From: [James McFadden](#)
To: [Scanlon, Amy](#)
Subject: Milwaukee Road Depot
Date: Wednesday, March 01, 2017 1:44:39 PM
Attachments: [Washington Market Enclosure Detail 02.21.17.pdf](#)
[ATT00001.htm](#)
[Washington Market Landmarks 02.26.17.pdf](#)
[ATT00002.htm](#)

Enclosure Detail @ 1/2" = 1'-0"
 The Washington Market
 640 West Washington Avenue
 February 21, 2017

Revised

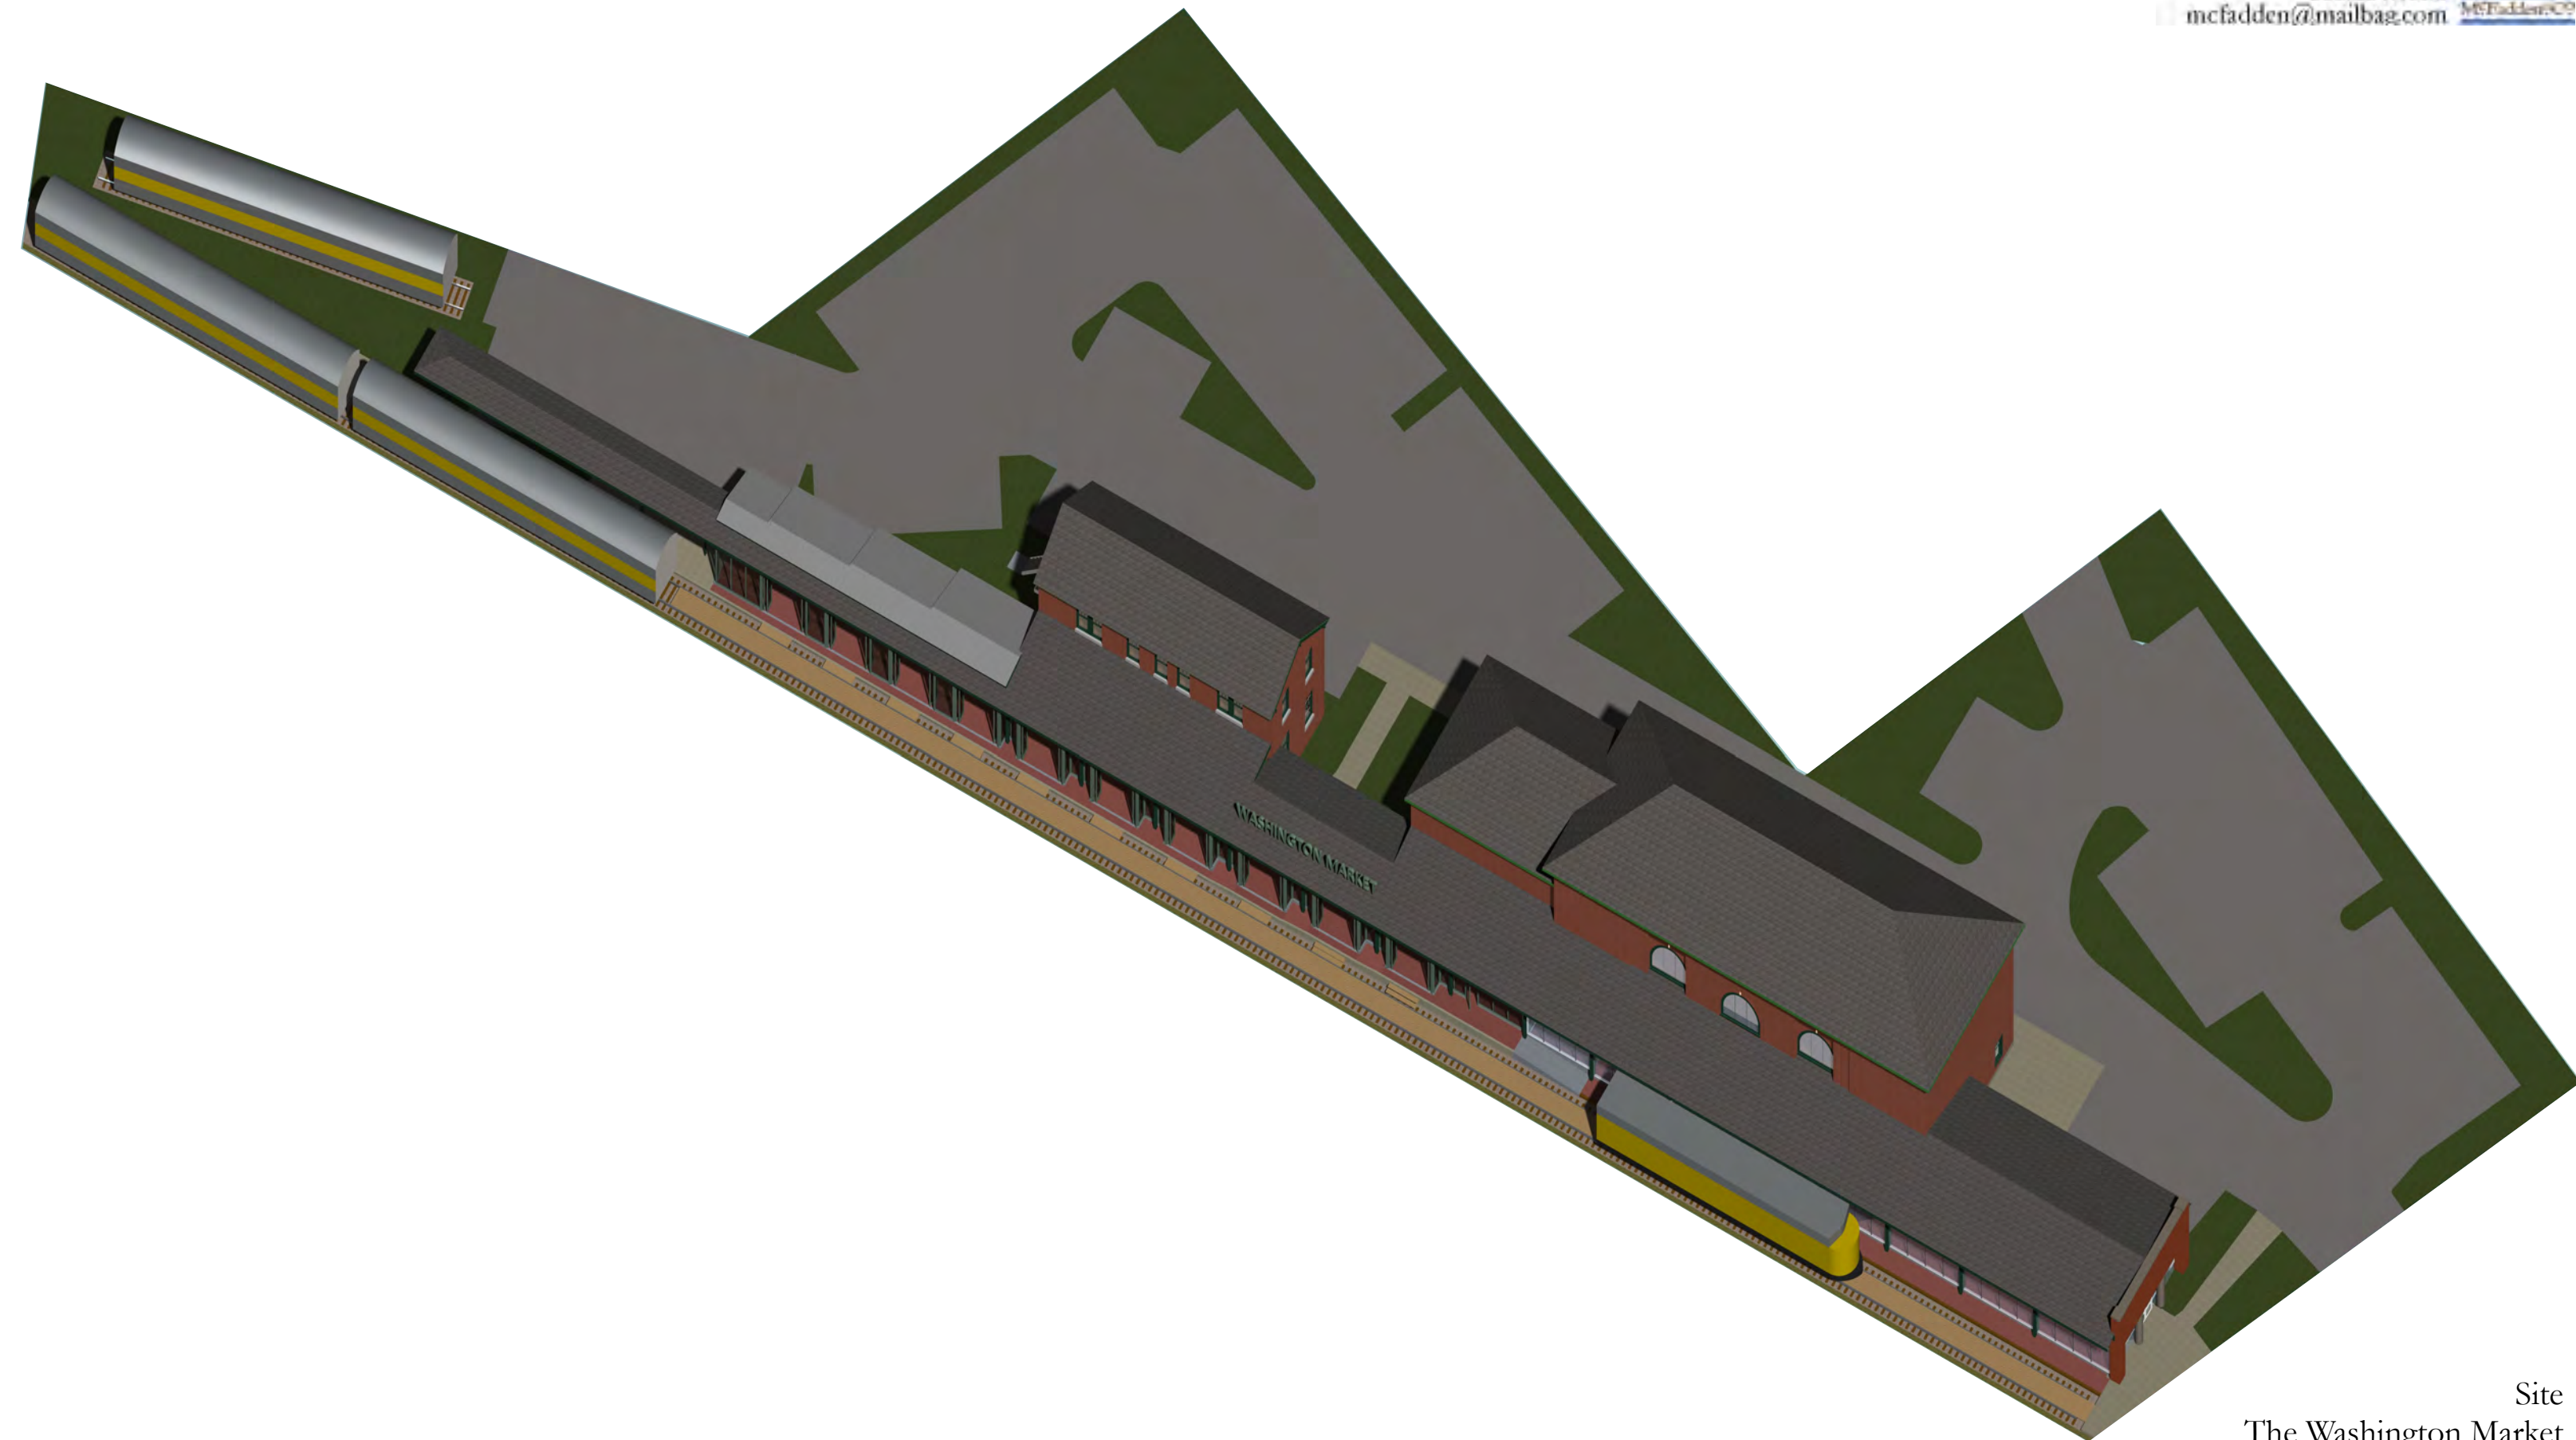
5. The platform enclosure has been reworked a bit at the columns. Originally the thought was to simply copy the approach utilized in the bike shop which is to place a new column behind each original one with glazing dying into each side. This looks fine in a frontal elevation but detracts from the view of the original column in fact. (See Washington Market Enclosure)

View from the Northwest
 The Washington Market
 640 West Washington Avenue
 February 26, 2017

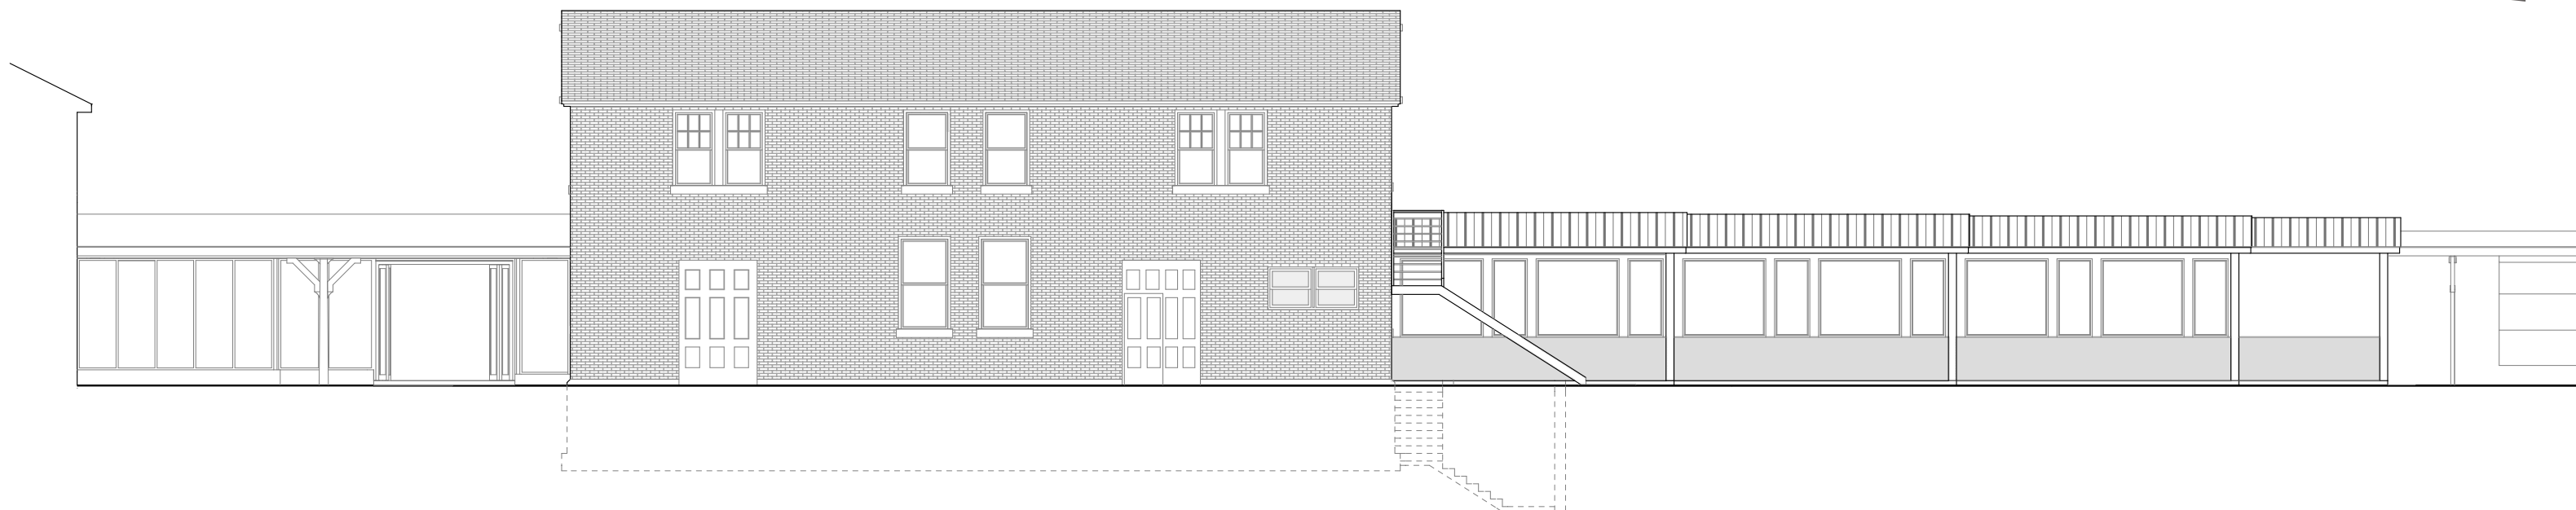
3. We have barely begun to discuss signage.
4. The added roof has been reworked so as to clearly differentiate it from existing canopy and if need be allow its future removal with minimal impact on the existing. (See View from Northwest, North Elevation & Proposed Section through Canopy)

6. The new roof will be metal to distinguish it from the existing asphalt shingles. (See View from Northwest, North Elevation & Proposed Section through Canopy)

North Elevation @ 1/12" = 1'-0"
 Bandit @ The Washington Market
 February 26, 2016

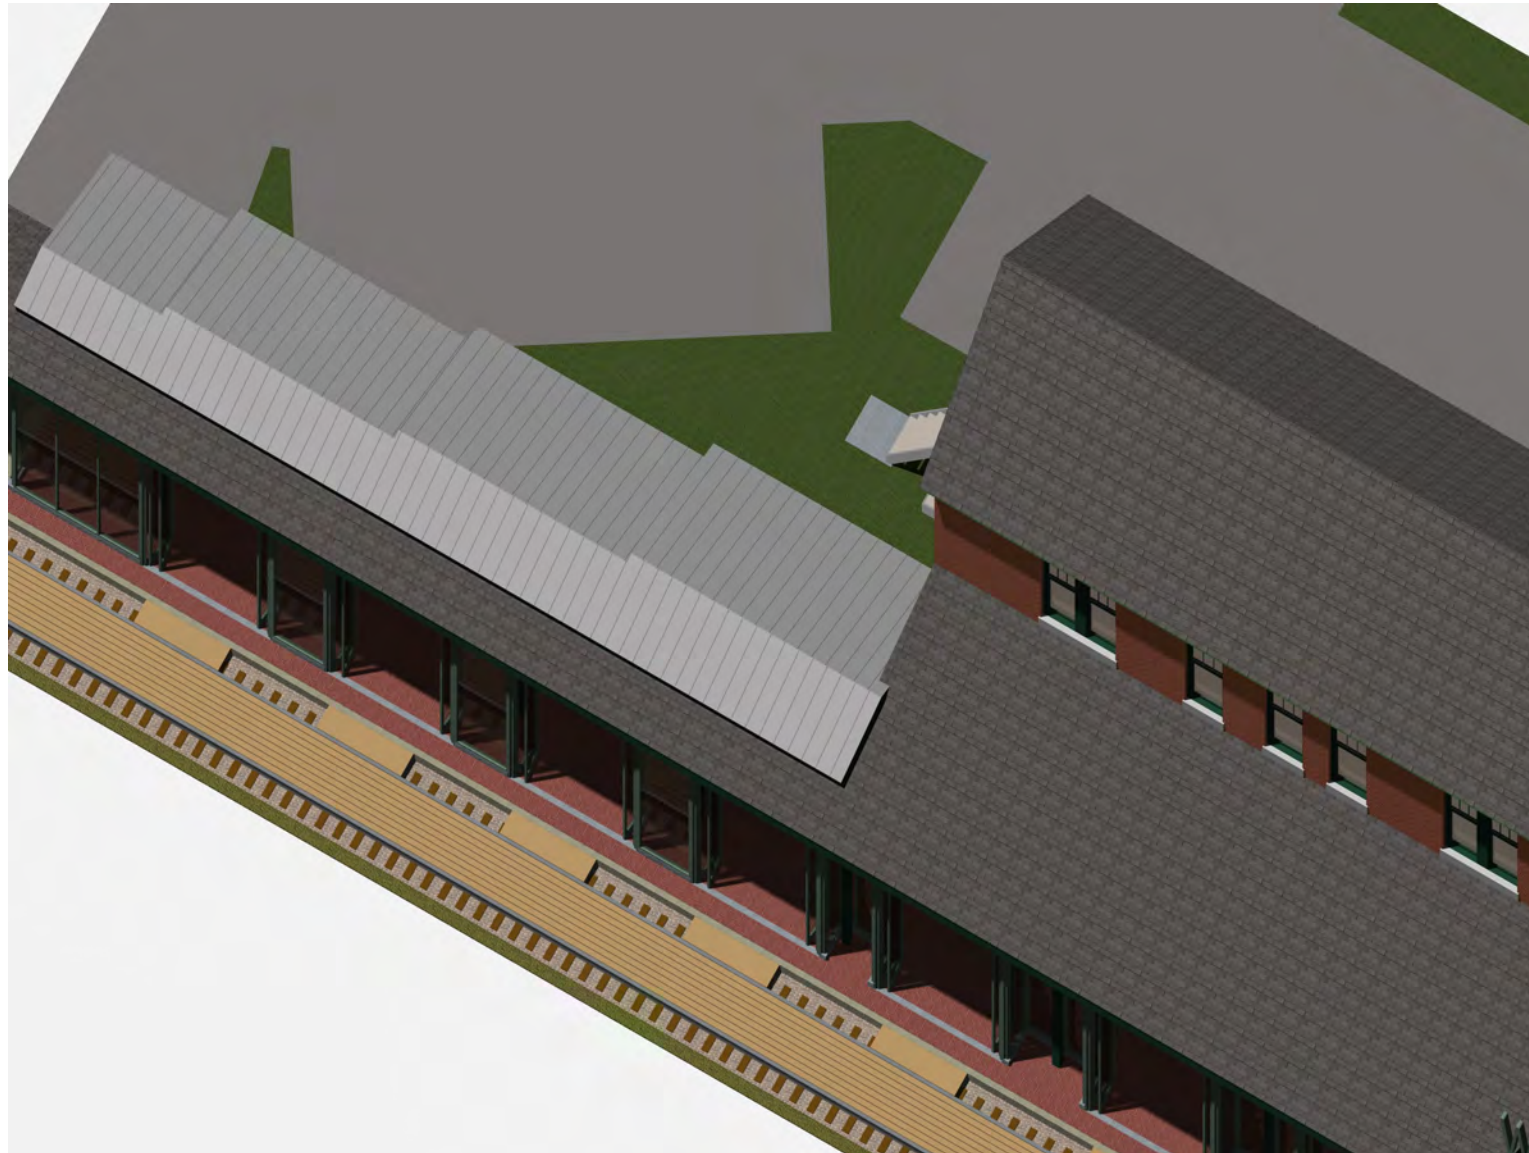
7. The new door will be a painted wood panel (See North Elevation)
8. The new exit stair will be as steel and minimalist as practical. It will be bolted to the existing wall in such a way to allow removal at some latter date. The stair down will have a flight down parallel with and exposing a portion of baggage house foundation wall. There will be a landing at the level of the footing exposing its top to view. (See Detail View of Exterior Stair)

Proposed Section through Canopy @ 1/4" = 1'-0"

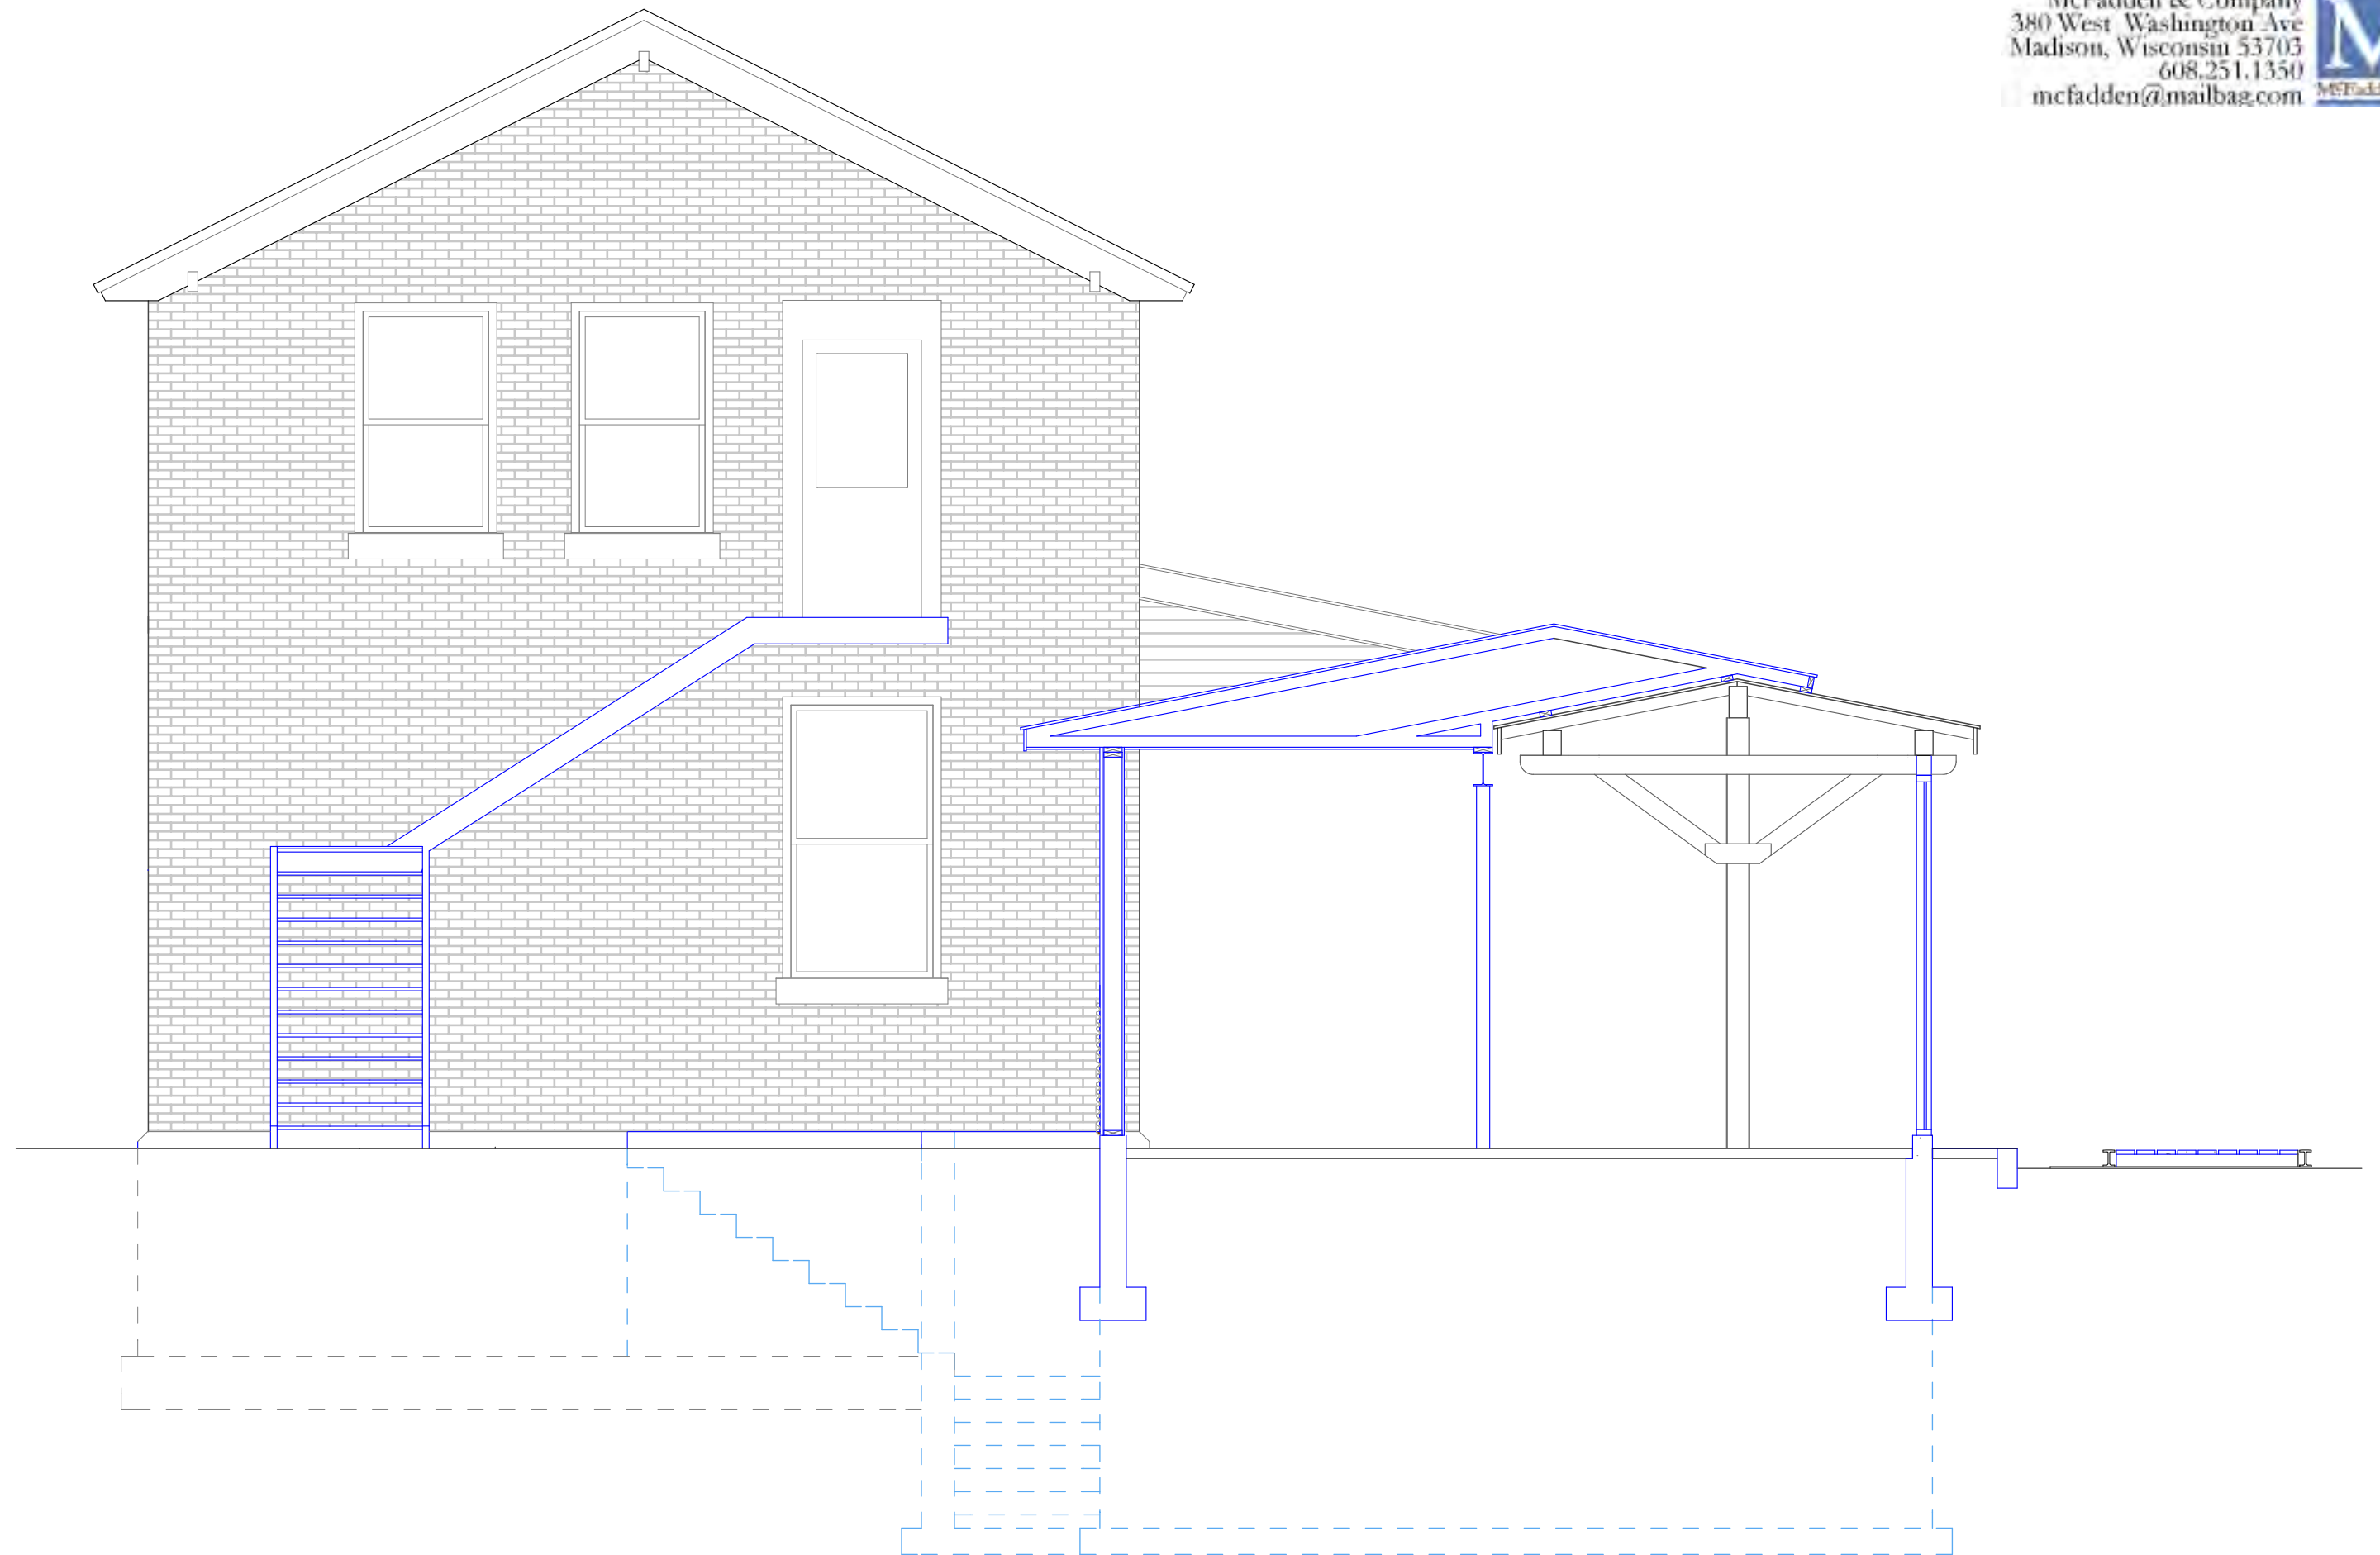
1. The new boardwalk will constructed of 5/4" composite decking installed over sleepers laid on the existing railroad ties and installed between and parallel with the existing rails. This boardwalk will be accessed via 10' wide platforms of similar construction located at the openings. The rails, approximately half the ties on the north side and all the ties on the south side will remain visible. (See Detail View of Boardwalk & Proposed Section through Canopy)
